**Addendum No. 001**

**Subject: 2020 Classroom Modernizations**  
**SDP Contract Numbers: B-028 C of 19/20 & B-030 C of 19/20**

**Location: Overbrook Educational Center**  
**6722 Lansdowne Ave, Philadelphia PA 19151**

**This Addendum, dated March 6, 2020, shall modify and become part of the Contract Documents for the work of this project. Any items not mentioned herein, or affected by, shall be performed strictly in accordance with the original documents.**

1 ELECTRICAL SECOND FLOOR POWER PLAN  
E2.2  
1/8" = 1'-0"

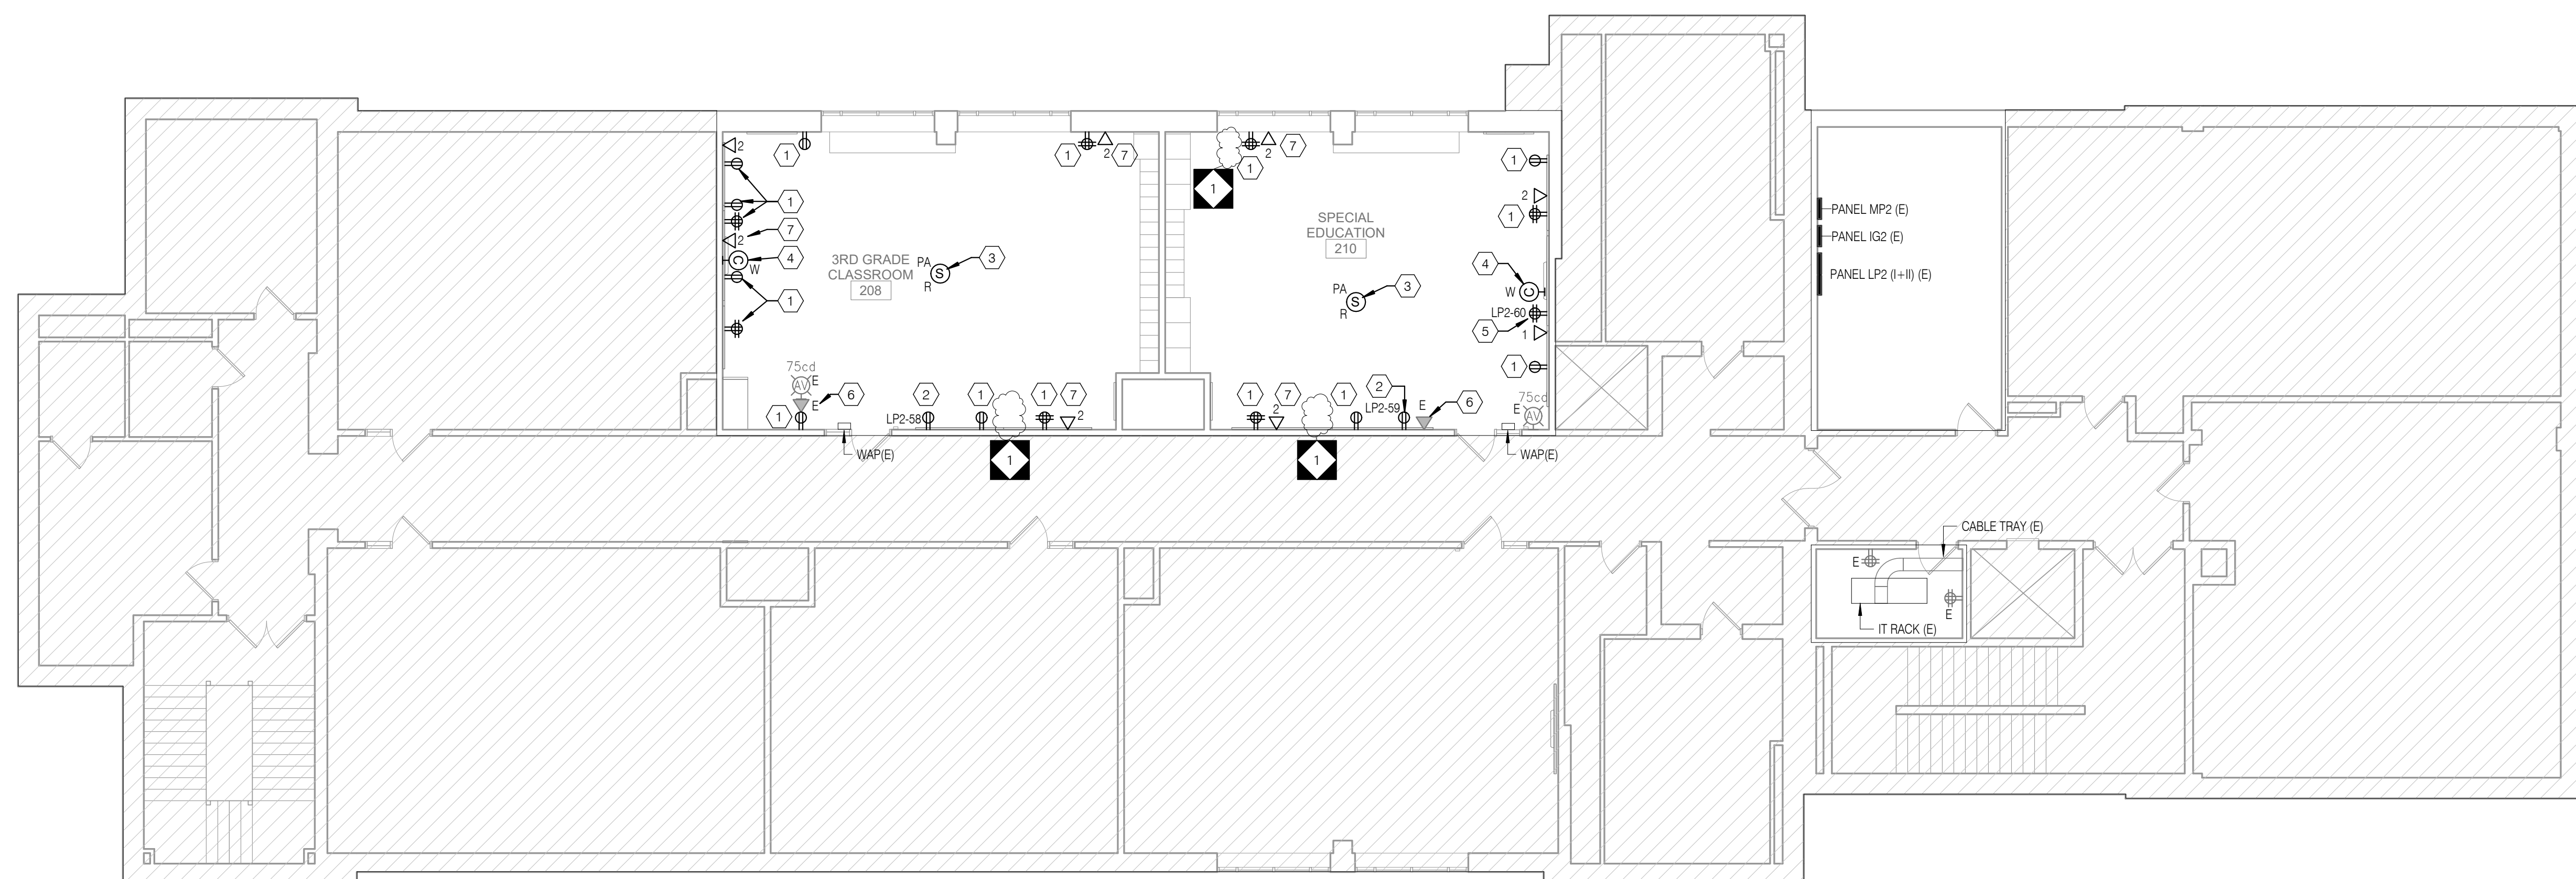
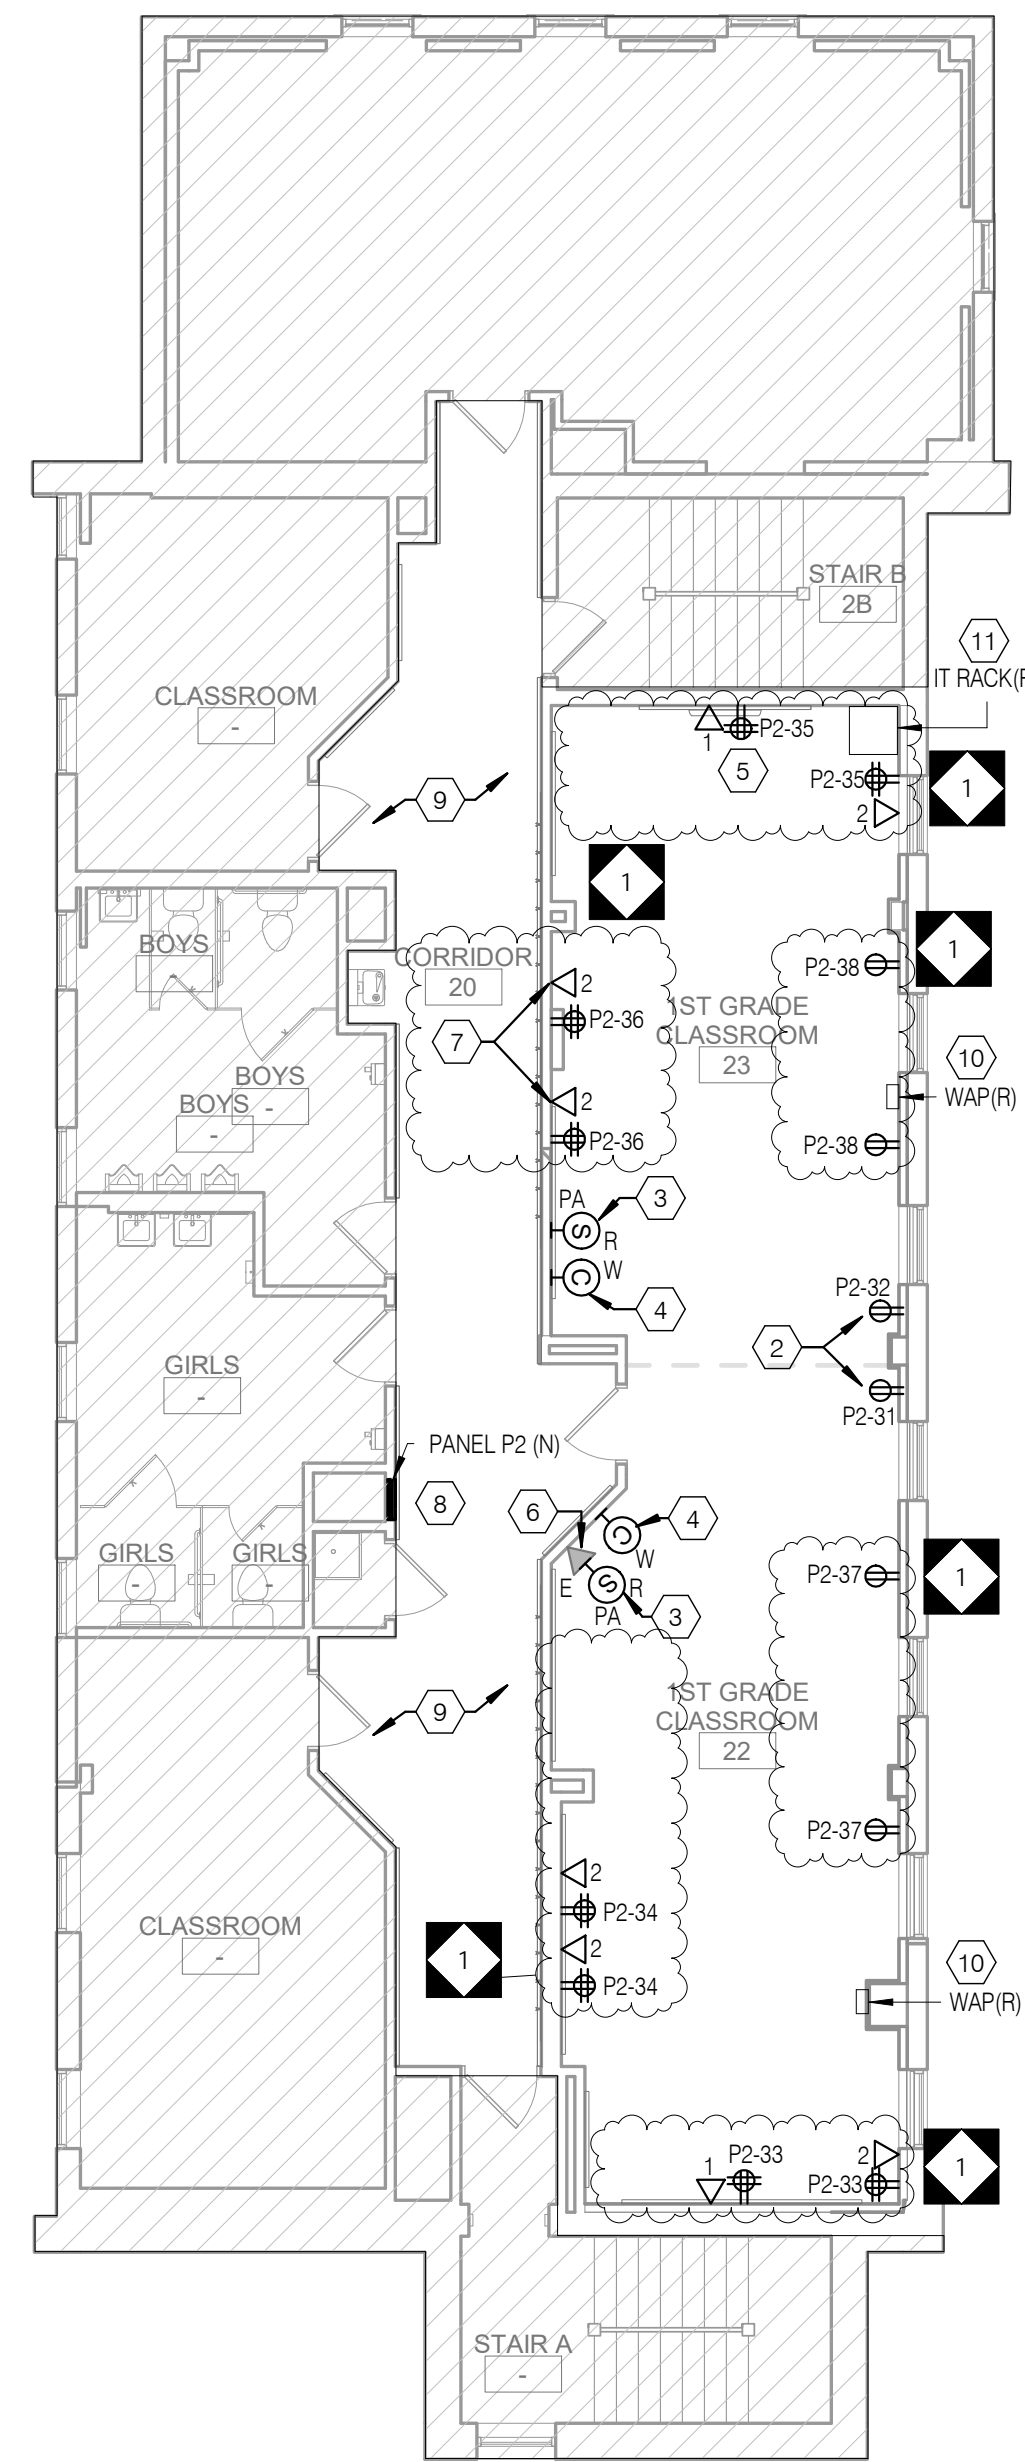
1. ADD general sheet note #6 to read "ELECTRICAL CONTRACTOR TO RUN ALL NEW SURFACE MOUNTED CONDUITS AND RACEWAYS IN CORNERS OFF EACH CLASSROOM TO AVOID CONFLICT WITH DISPLAY BOARDS AND OTHER CLASSROOM FURNISHINGS."
2. REVISE receptacle and data layouts per the revised smart board locations.

3 TYPICAL CLASSROOM LIGHTING CONTROLLER  
E7.1 NTS

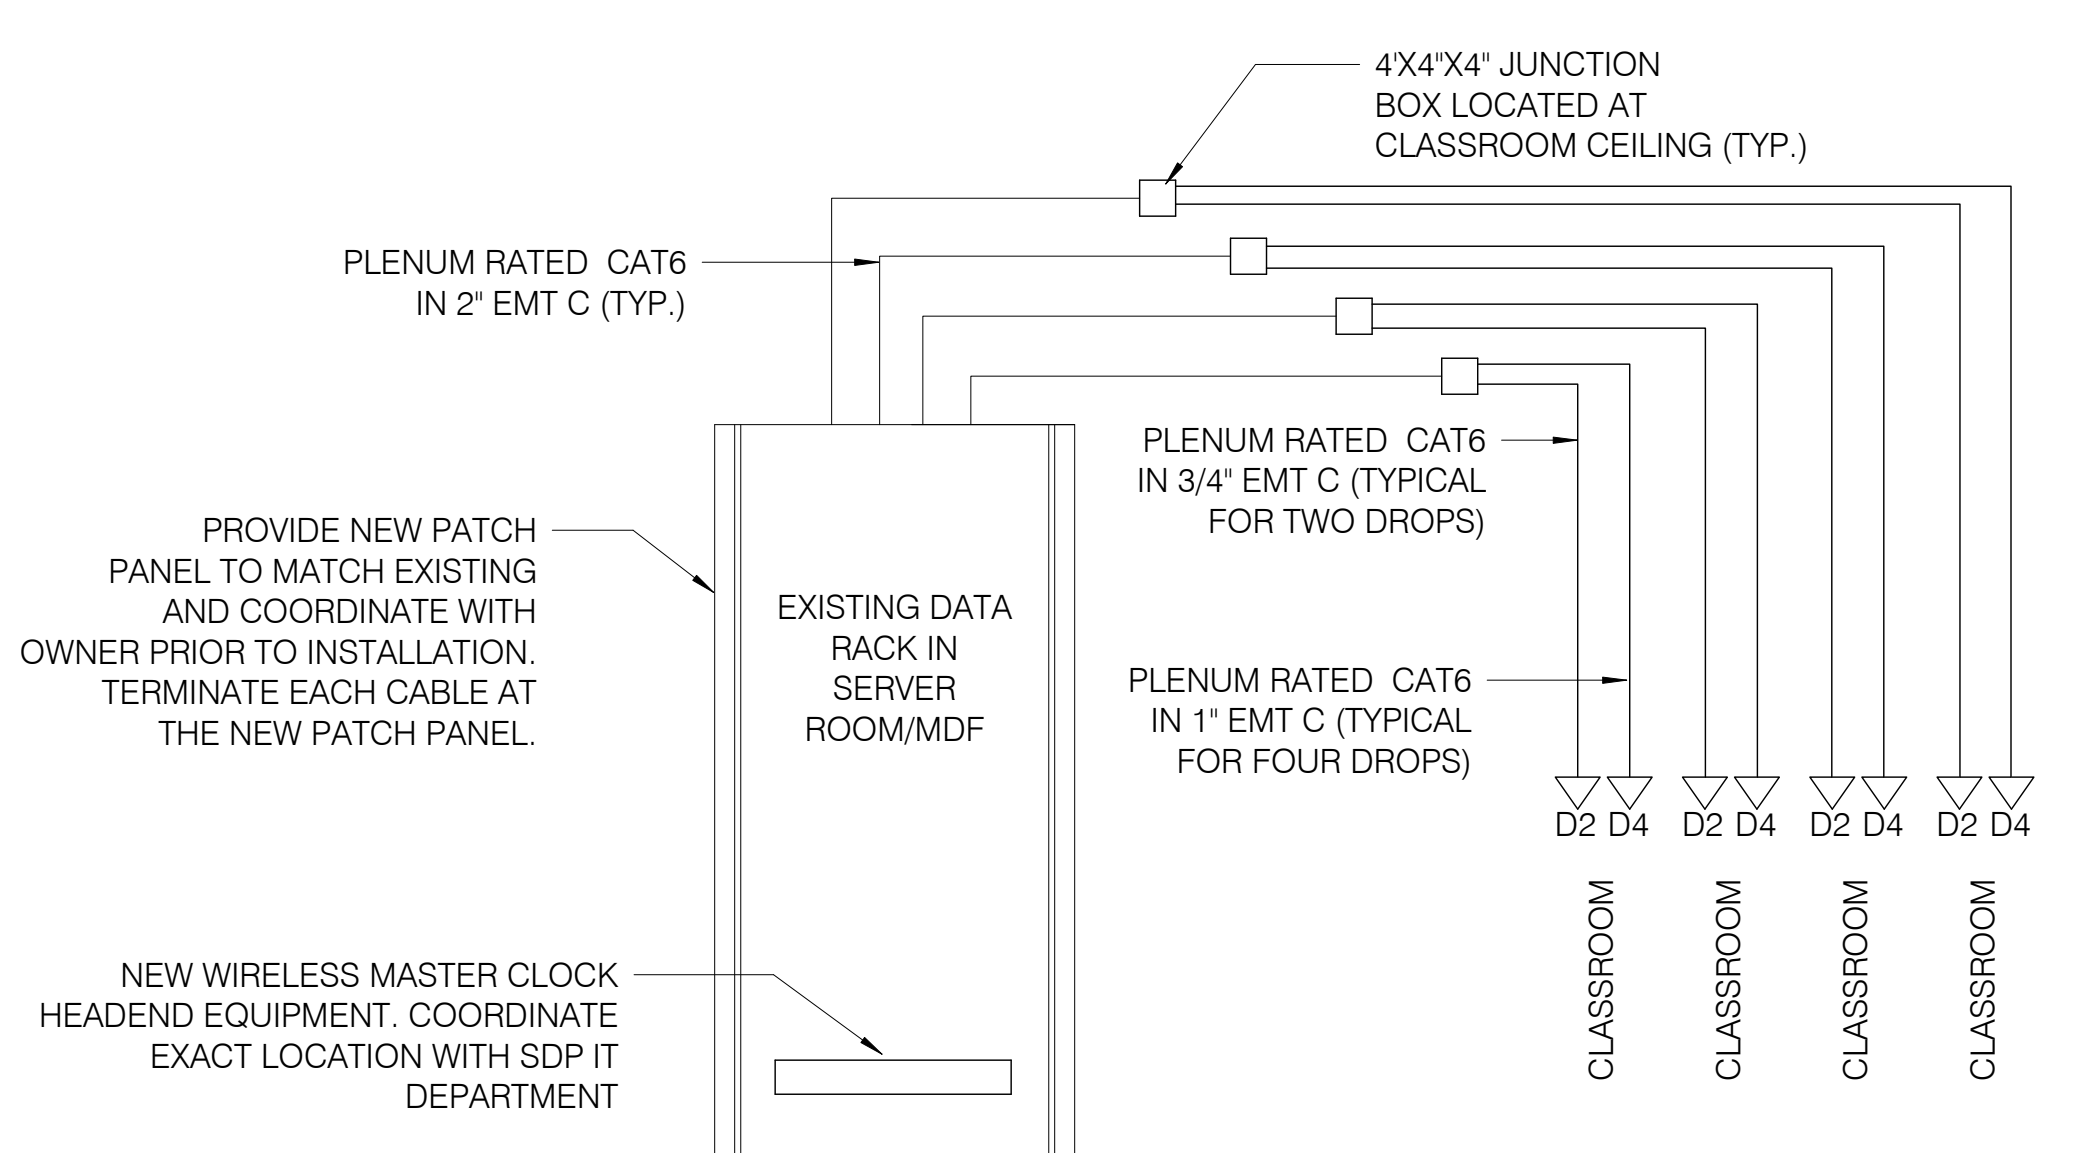
1. REVISE 3/E7.1 Typical Classroom Lighting Controller diagram as indicated on the drawings.

DRAWING NO.  
**MPD1.1**

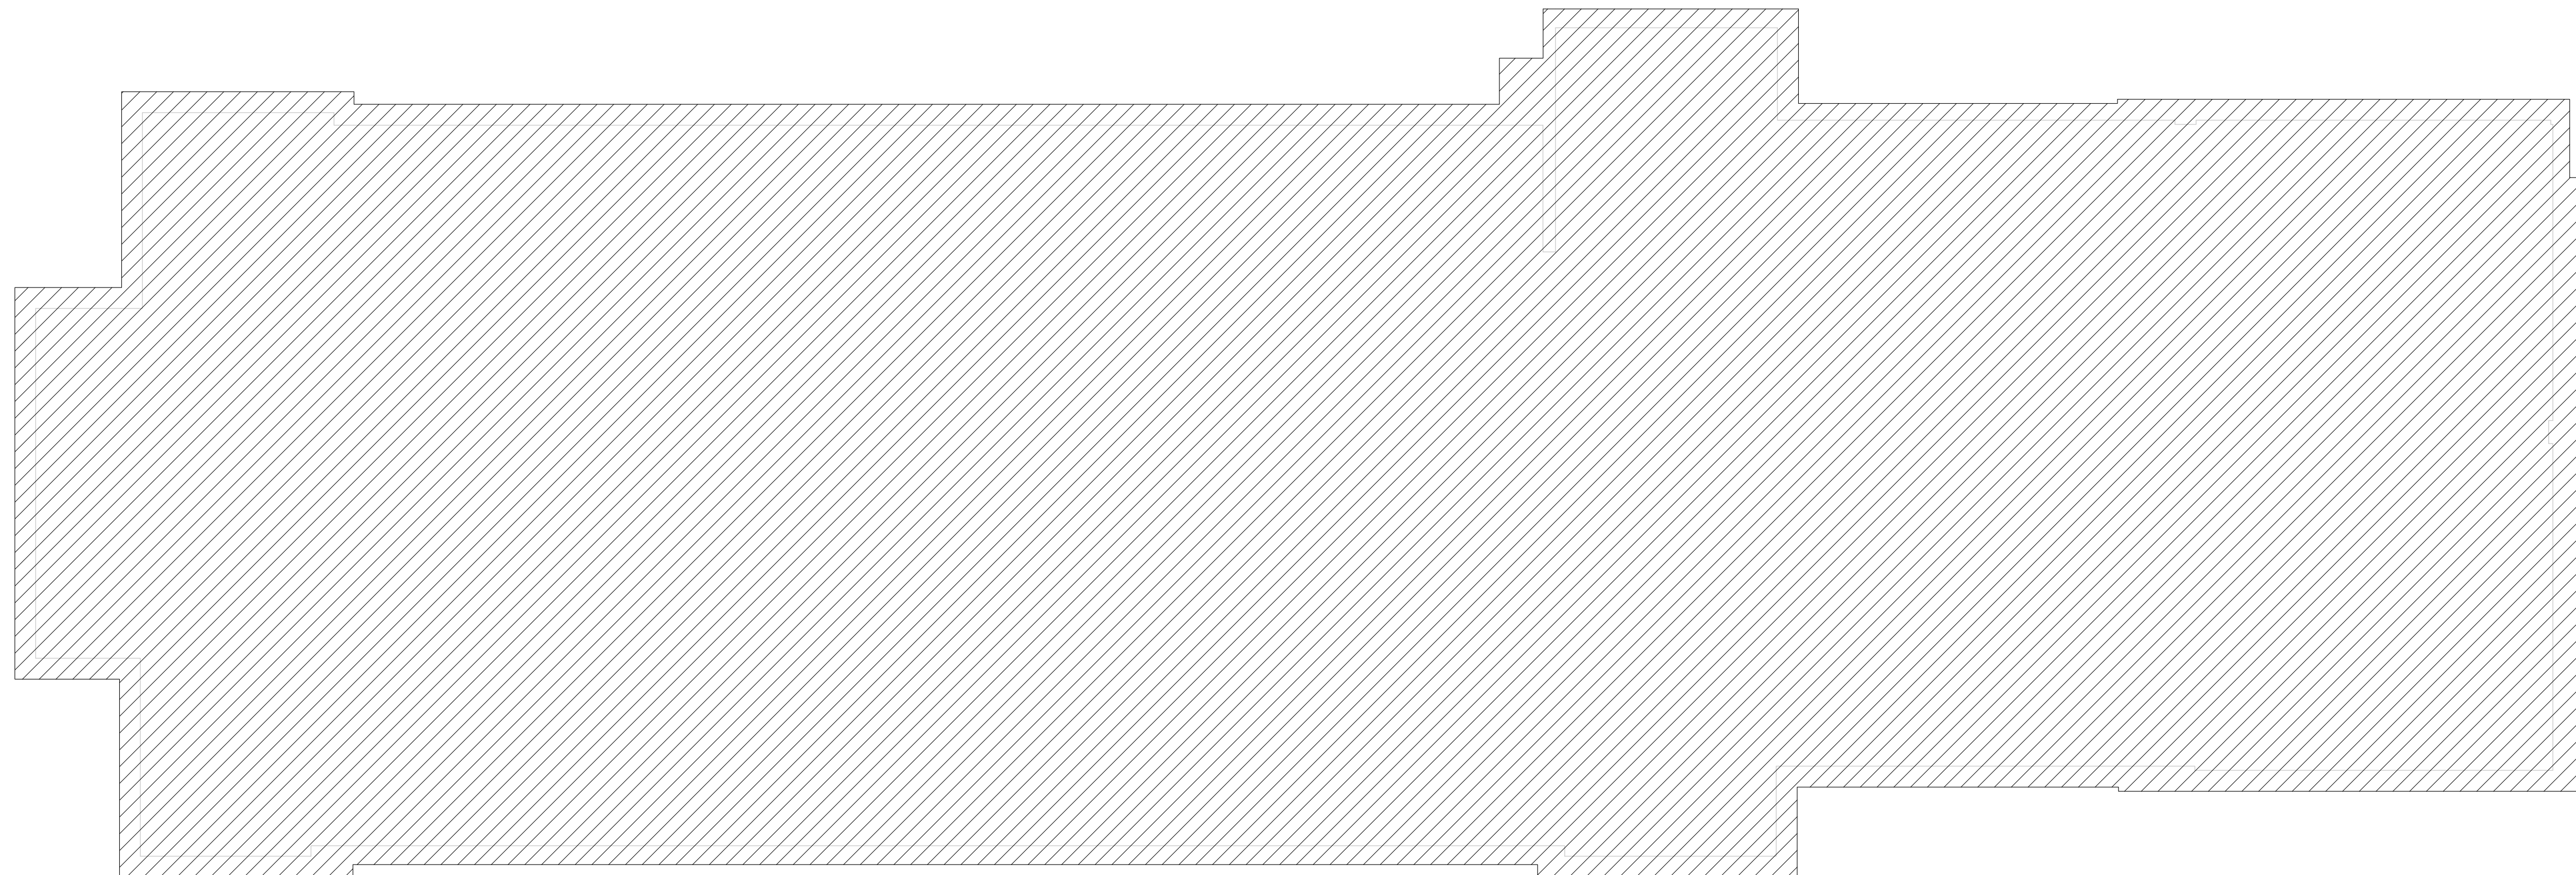
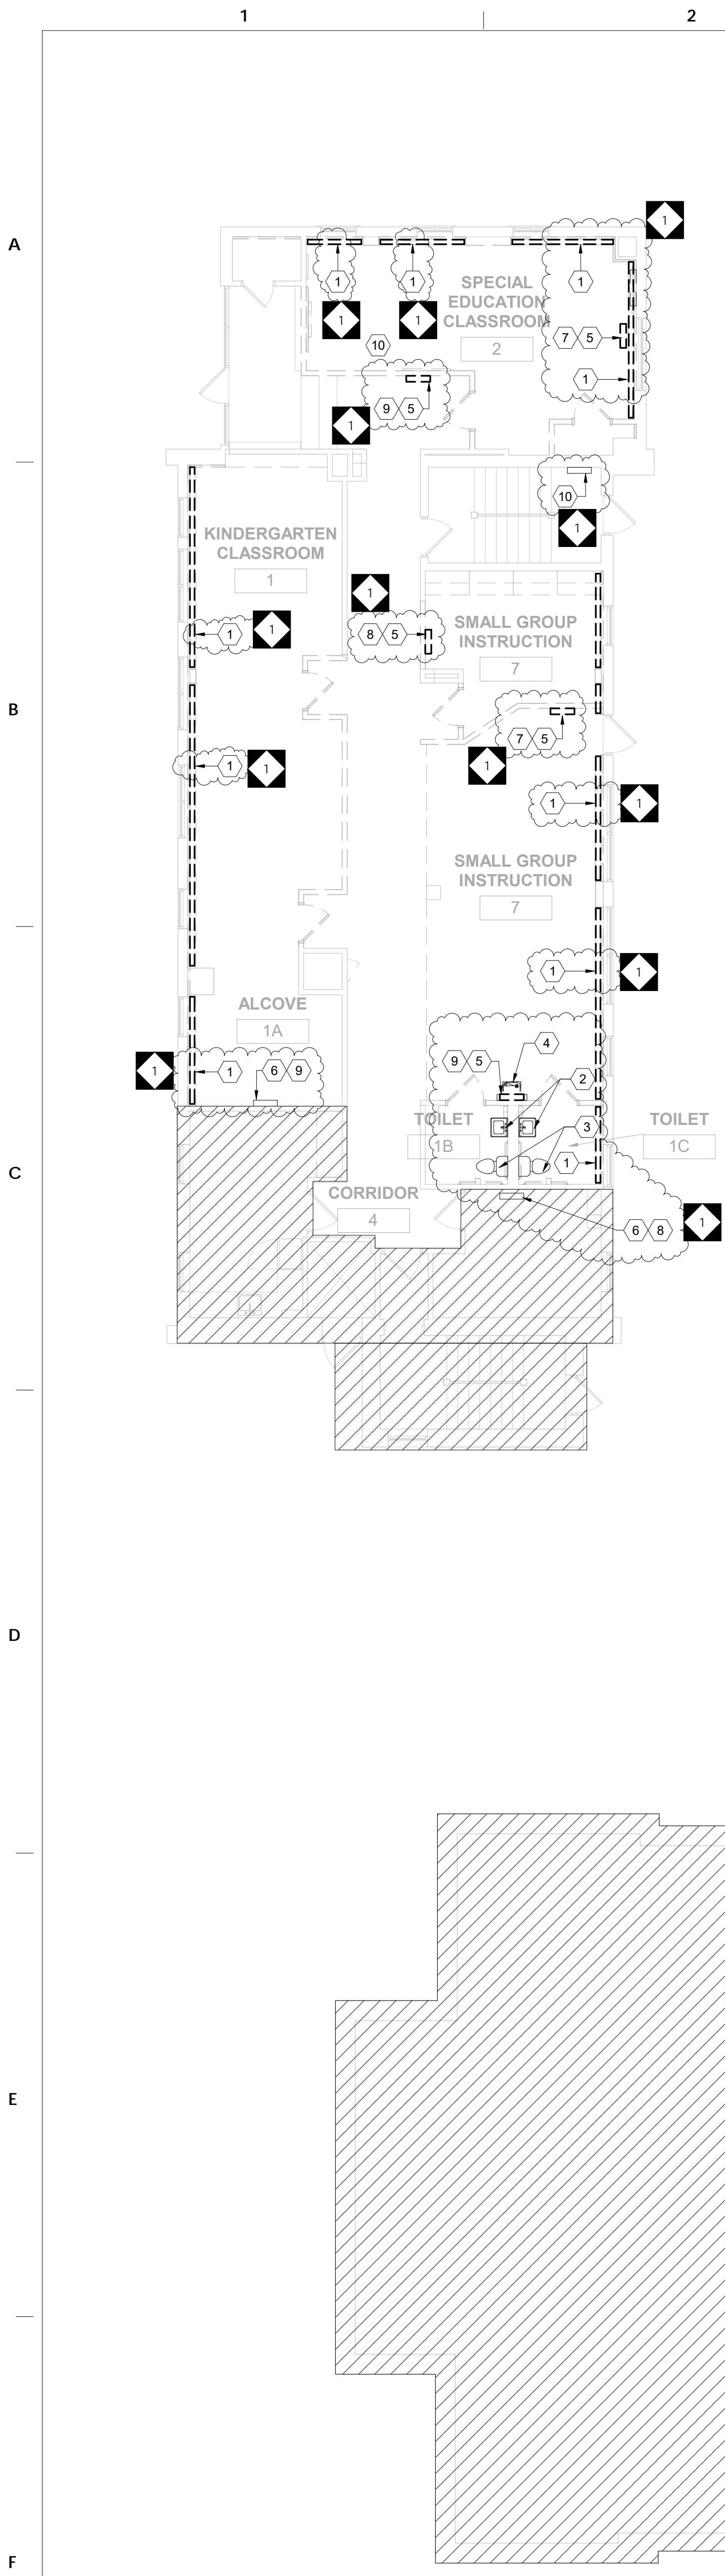
1. REVISE sheet number.
2. ADD Demolition Keyed Notes and floor plan as indicated on the drawings.
3. REVISE scope as indicated on the drawings.
